Shenzhen Double New Technology Co.,Ltd
301B, No.13, phase I, zone 3, Xinhe community, Fuhai street, Bao'an District, Shenzhen, China

Class II Permissive Change Letter

FCC ID: **2AVAA-XN002**

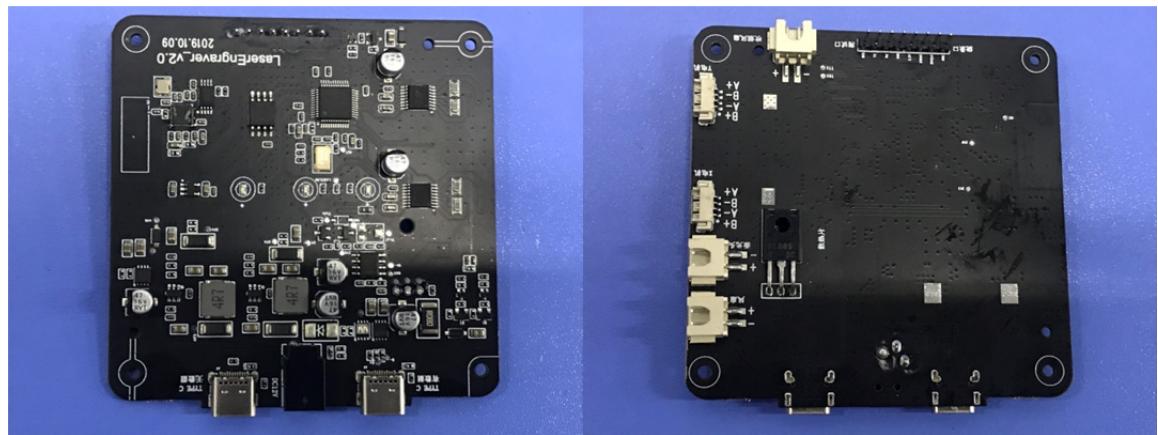
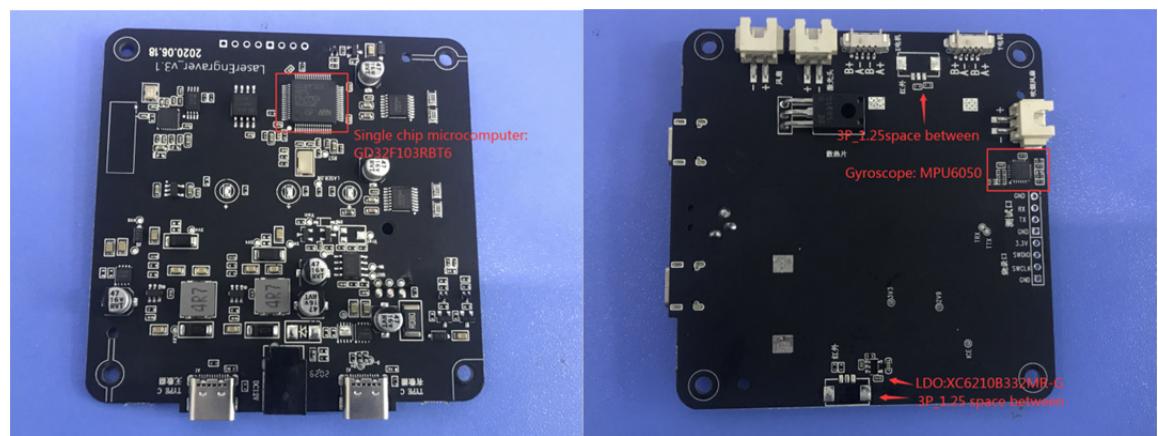
Replaced the AC-DC adapter and some electronic components sold together with the laser machine, there is only change of non-transmitter portions, Conducted Emissions & Field Strength of Spurious Radiation testing was performed to demonstrate RF compliance.

Old Model: Adapter Model:GQ24-120200-AU Input: 100-240V~, 50/60Hz, 1A Output: 12V---2A	
New Model: Adapter Model:MA24W1-1202000U Input: 100-240V~, 50/60Hz, 0.7A Output: 12V---2A
